Is the North Spur dam safe?

I have written several articles about my concerns regarding the safety of the North Spur dam, concluding in my last article that the dam was not safe. However, on undertaking a more detailed analysis of the NALCOR reports, I have changed my mind, and now believe the dam to be safe.

Figure 1.

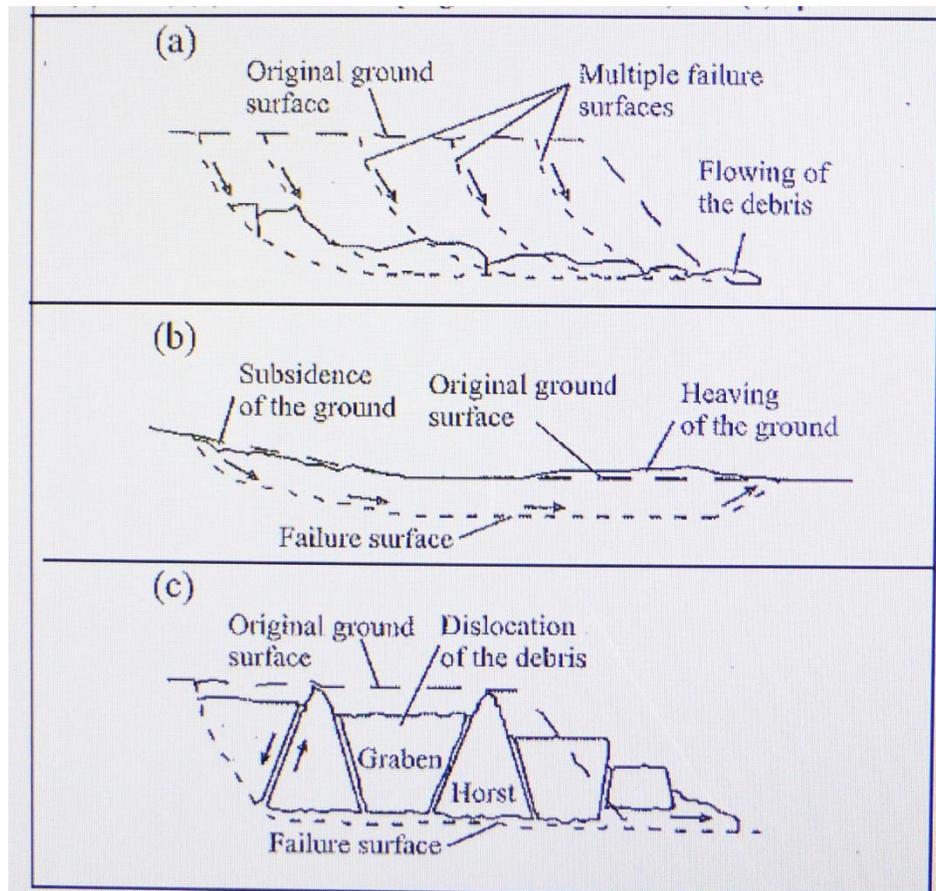
My initial concerns centered on the report by Dr. Bernander identifying many progressive landslides in the river valley near the North Spur. What is a progressive landslide – it is a landslide which can occur in soft (quick) clays where the land mass slides downhill on failure of a weak zone below the surface, as shown in Figure 1, sections (b) and (c).

Dr. Bernander, after inspecting the river banks and the North Spur shoreline, concluded “For the most recent large slide in the North Spur, in 1978, Nalcor’s own engineers found that the silty clay layer **had developed multiple failure surfaces and liquefied over a long lateral distance**”. Sources Bernander 2015 report, pages 7. No such statement could be found in the NALCOR 2015 report, on liquefaction in the 1978 landslide. In fact, the landslide is identified as being of the flow type – see Figure 1 (a) – “The slide involved a block movement triggered by weak layers

Figure 2.

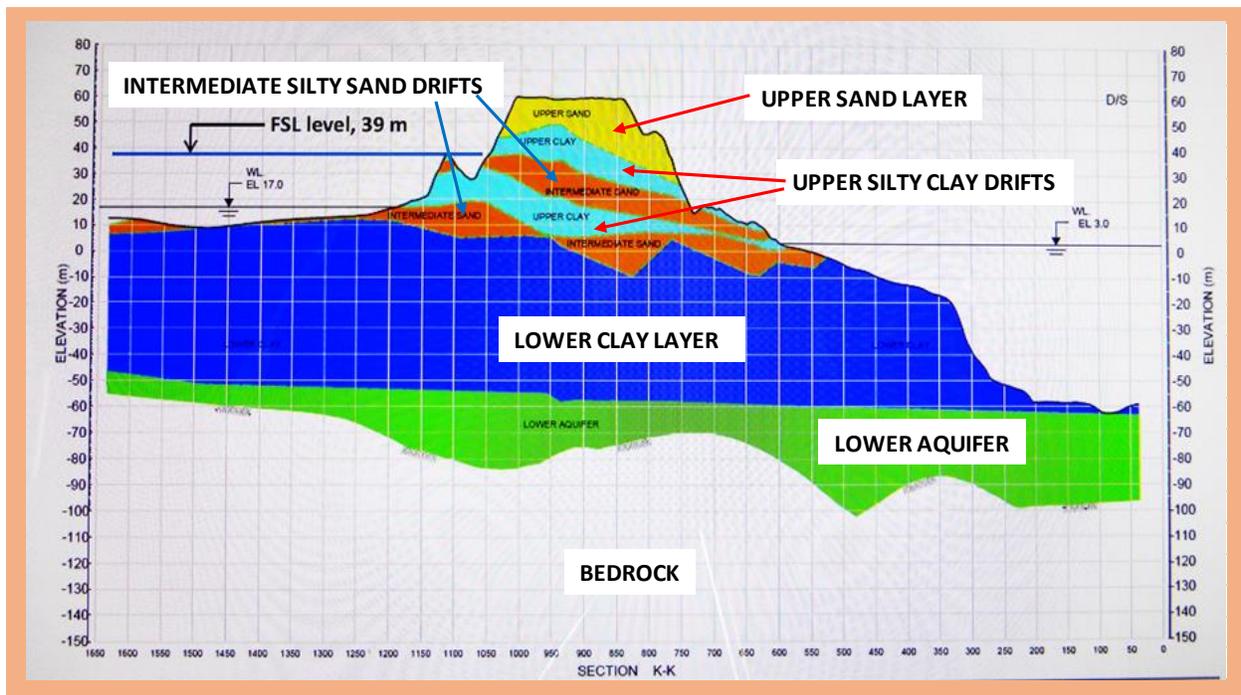
A few tests on soil samples retrieved from the two "Upper Silty Clay Drifts" – see Figure 2 have indicated the presence of soft clays. The sensitivity ranged from 1 to 36 in 43 samples, with an average of 10. Source NALCOR 2016 report. Page 91. This is not soft enough to be considered "quick", according to Carlton U. Moreover, during the excavation work required to re-shape the North Spur, there were no instances of liquefaction nor small landslides. All clay removed by shovels and dumped into trucks remained in clumps. This indicates that the pockets of quick clay (if any) were far too small to cause landslides.

Dr. Bernander also reviewed the data available on the lower clay layer (See figure 2). This layer provides the foundation for all the soils above water level in the North Spur. Again, Dr, Bernander concludes *"... that layers with high sensitivity also occur in the Lower Clay formation – a fact that allows the possibility of developing a progressive failure"*. Source Bernander 2016 report, page 8.

On the other hand, NALCOR data from tests on soil samples retrieved from the lower clay layer do not indicate the presence of soft clays. Instead, the clay is characterised as *"stiff to very stiff"*. All tests on this deposit indicate sensitivities well below 30, hence no quick clay. Quote - *"sensitivity values obtained for this unit vary between 2 and 11, with an average of 4"*. Source – NALCOR 2016 report, page 98.
